T10/06-470 revision 3

Date: January 12, 2007

Subject: SAS-2: Transport layer read data flowchart

Figure 1 — Representation of transport layer (i.e., ST_TTS1 and ST_TTS3) read data operation

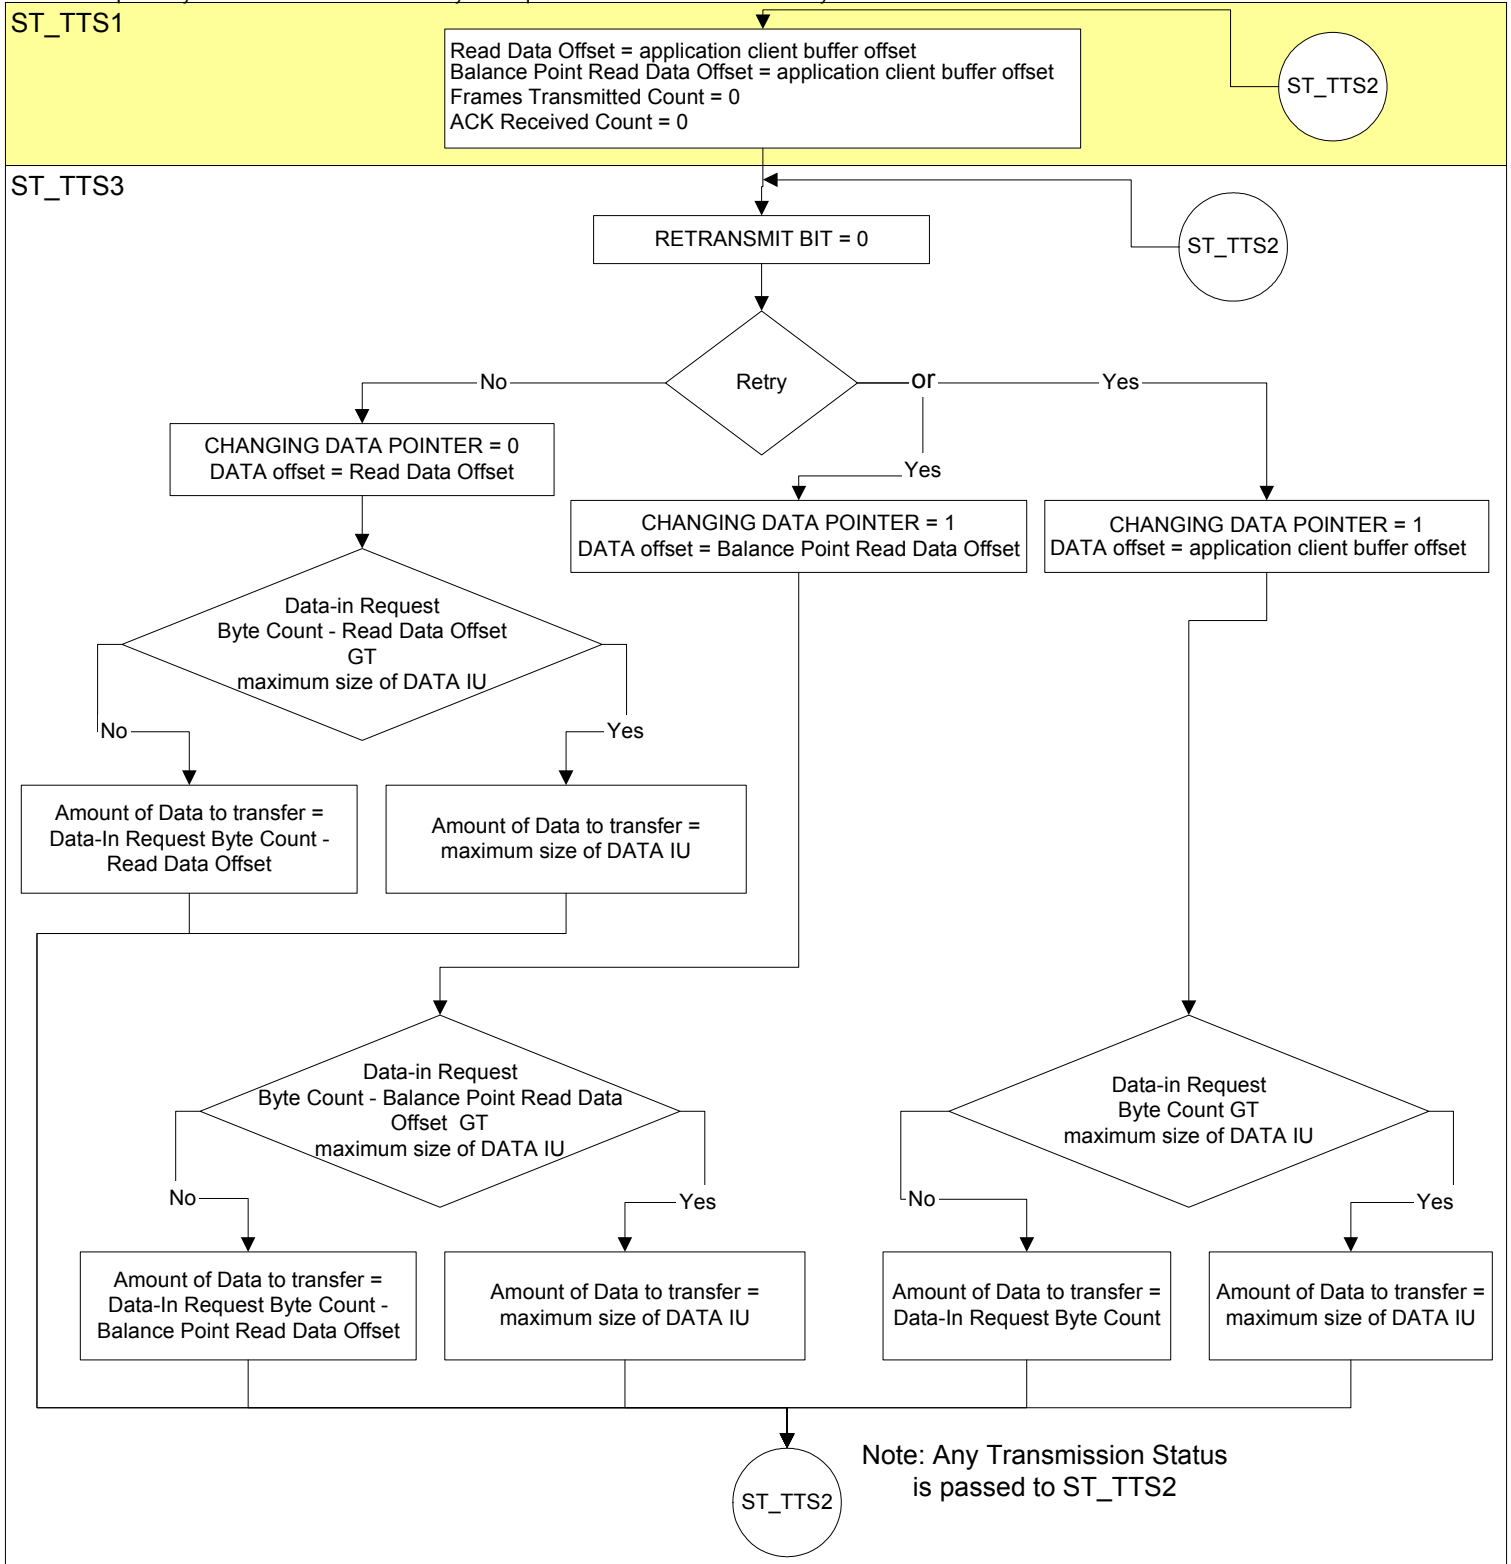
In the process of converting the words that are currently in SAS-2 there were no errors found, however, some of the wording may be somewhat unclear. Also, it was discovered that one of the conditions described in ST_TTS3 can never happen and another is already checked in ST_TTS2 so this proposal is recommending that they be deleted. See below the flowcharts for the suggested changes.
